COMMENTS BY THE TEXAS COMMISSION ON ENVIRONMENTAL QUALITY AND THE PUBLIC UTILITY COMMISSION OF TEXAS REGARDING THE PROPOSED STATE OF TEXAS REGIONAL HAZE AND INTERSTATE VISIBILITY TRANSPORT FEDERAL IMPLEMENTATION PLAN

DOCKET ID NO. EPA-R06-OAR-2016-0611

Figure 1: EPA SO_2 Emission Trend Data for Milton R. Young Unit 1 (Source: Docket ID No. EPA-R06-OAR-2016-0611-0008, TX187-0008-0033-BOD-Selected BOD SO2 Averages-3)

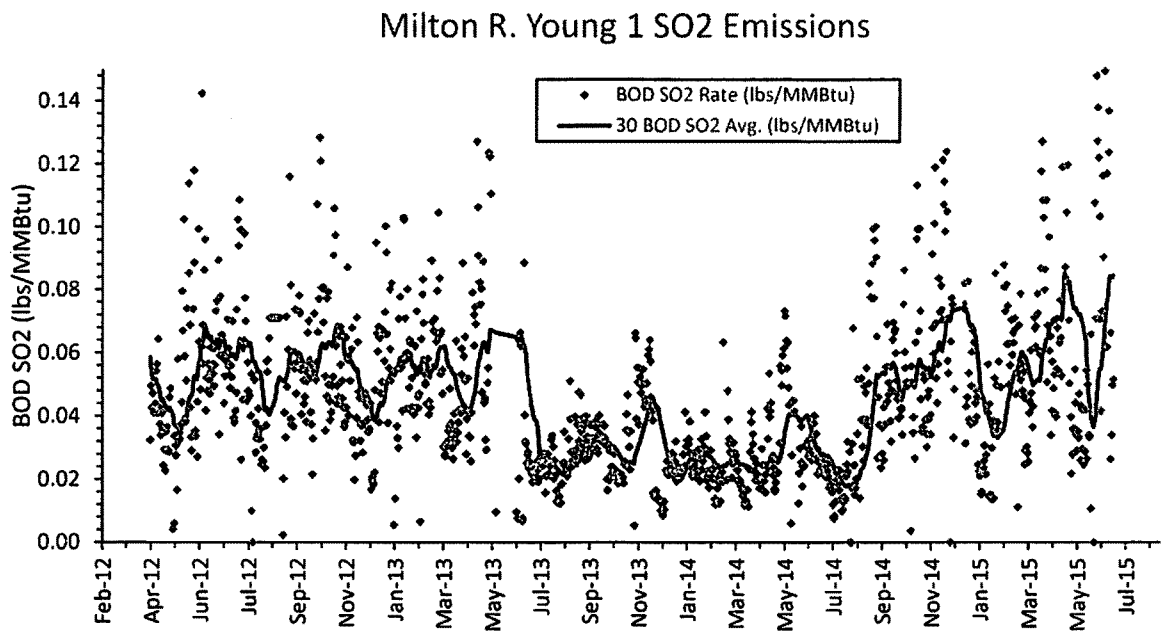
EPA Region 6 has not justified why its proposed BART determinations for SO_2 control on coal-fired EGUs in Texas are inconsistent with other EPA BART determinations. The proposed SO_2 limit for retrofit wet scrubbers on lignite-fired units is not supported by the EPA's own data provided with the proposed FIP. The EPA should not arbitrarily assume that wet FGD scrubbers on lignite-fired units can achieve the same level of SO_2 emission rate on a lb/MMBtu basis as low-sulfur PRB subbituminous coal-fired units.

Figure 2: EPA SO_2 Emission Trend Data for Jeffrey Energy Center Unit 3 (Source: Docket ID No. EPA-R06-OAR-2016-0611-0008, TX187-0008-0033-BOD-Selected BOD SO2 Averages-3)

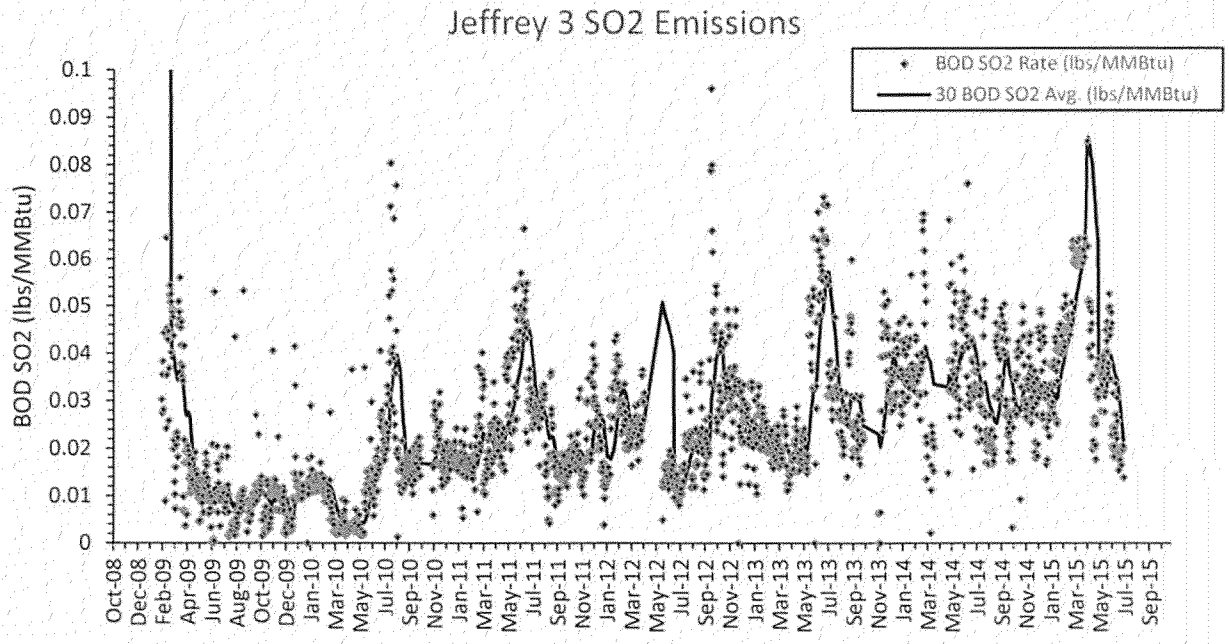
The EPA's proposed emission standards apply at all times, including startup and shutdown operations. However, the EPA has not given proper consideration to emission spikes that can occur during startup operations that can cause a significant spike in even a 30-boiler operating day average until the startup day rolls out of the 30-day average. The EPA's own emissions trend data provided in the technical support documents demonstrates that such spikes would represent a compliance problem for some of the units that the EPA evaluated in establishing the proposed BART emission standards. Figures 2 and 3 provide examples from the EPA's technical support document with selected 30-boiler operating day average data (Docket ID No. EPA-R06-OAR-2016-0611-0008, TX187-0008-0033-BOD-Selected BOD SO2 Averages-3) for two units with wet FGD. While all the spikes in the SO_2 emissions trend for Jeffrey Energy Center Unit 3 and James H. Miller Unit 4 may not necessarily be associated with startup operations, the EPA's data demonstrates the significant variation that can occur in SO_2 emission rates even when using a 30-boiler operating day average which the EPA has not accounted for in selecting the proposed emission limits for retrofit scrubbers.

Figure 4: Coal-fired EGU Age Profile (United States Department of Energy, EIA, 2015 Form EIA-860 data).

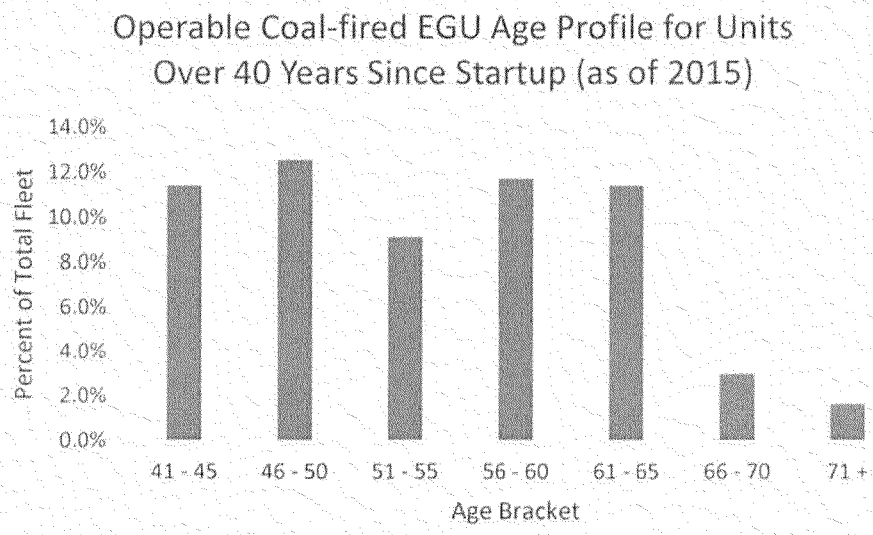
While coal-fired EGUs can remain operational for 60 - 70 years and the affected BART units could theoretically last another 30 years, the EPA's selection of 30 years for the remaining useful life of these units is arbitrary and does not take into consideration the current state of the energy sector and many other factors that will affect how long these units will continue to remain operational. The age of the coal-fired EGUs subject to the EPA's proposed FIP range from 35 to 46 years, which the average being approximately 40 years. EPA's assumed 30 years of remaining useful life assumes these units will remain operational until they are 65 to 76 years old. However, this assumption does not reflect actual operational life data from the United States Department of Energy, Energy Information Administration (EIA). Figure 4 presents the age brackets for operable coal-fired EGUs with over 40 years of operation, based on EIA's 2015 Form EIA-860 data. Less than 5% of the operable fleet in 2015 was greater than 65 years in age.

For units in EIA's 2015 Form EIA-860 data with expected retirement dates, the average expected age at retirement is only 53 years and the median age is 57 years. Based on just the current age profile of the units affected by the EPA's proposed FIP and the EIA information from Form EIA-860, the expected remaining useful life of these units is more likely between 10 - 20 years, not the 30 years assumed by the EPA. Other factors, such as the current energy sector market pressure and other regulatory impacts, could shorten the remaining useful life even further.

Figure 5: Cost Effectiveness Comparison for Welsh #1

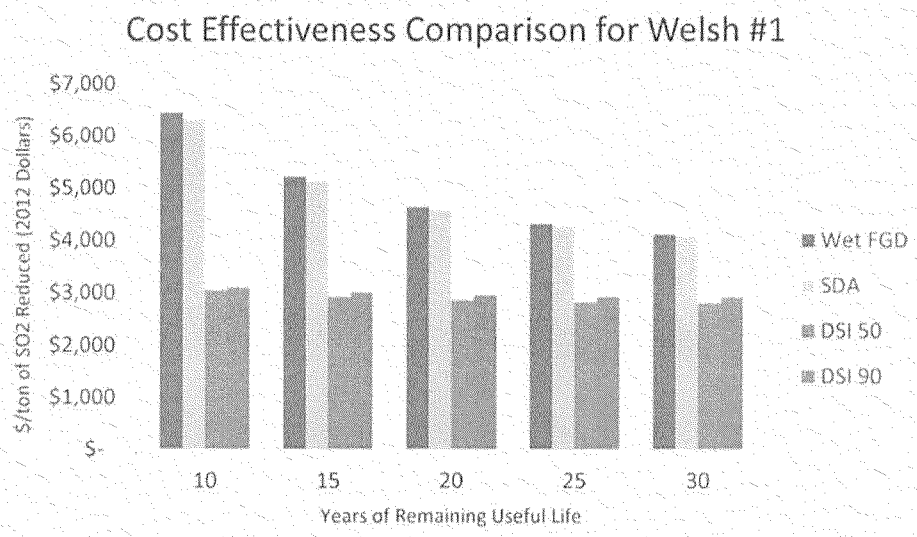
Furthermore, the EPA's cost effectiveness calculations of some of the technologies evaluated by the EPA are significantly biased as a result of using a 30-year time for annualizing capital costs. While the cost effectiveness of DSI remains relatively flat over different time periods for remaining useful life due to its relatively low capital costs, cost effectiveness estimates for wet FGD and SDA are significantly impacted by the time period assumed for remaining useful life due to the far higher capital costs associated with those technologies. Figure 5 illustrates the impact of remaining useful life assumed when calculating cost effectiveness on the same technologies evaluated by the EPA using the EPA's same cost estimates. The EPA's cost effectiveness estimates for wet FGD and SDA are severely underestimated as a result of the EPA's artificially high remaining useful life estimate.

Figure 6: Comparison of Natural Conditions Estimates

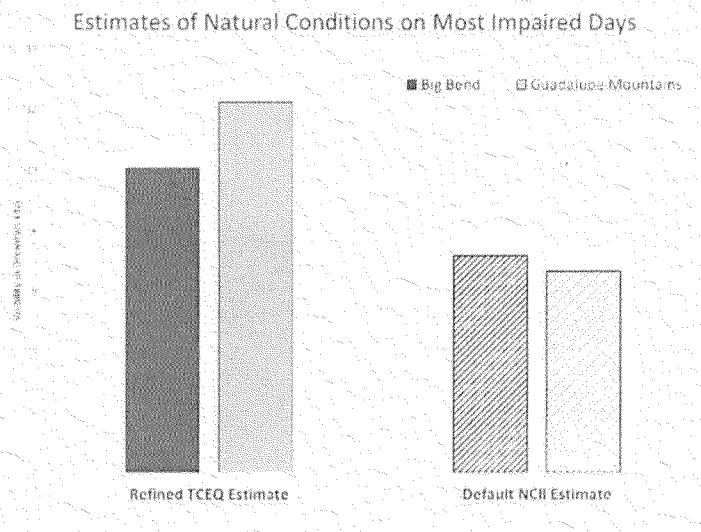
Specifically, Class I areas located in West Texas are heavily impacted by large dust storms and windblown dust from the surrounding highly erodible soils. These dust events should be considered when estimating the natural conditions for Class I areas in Texas. As shown in the figure below, the result of including this site-specific information is that the more

representative estimates of natural conditions calculated by the TCEQ are higher than the default NCII values used by the EPA.
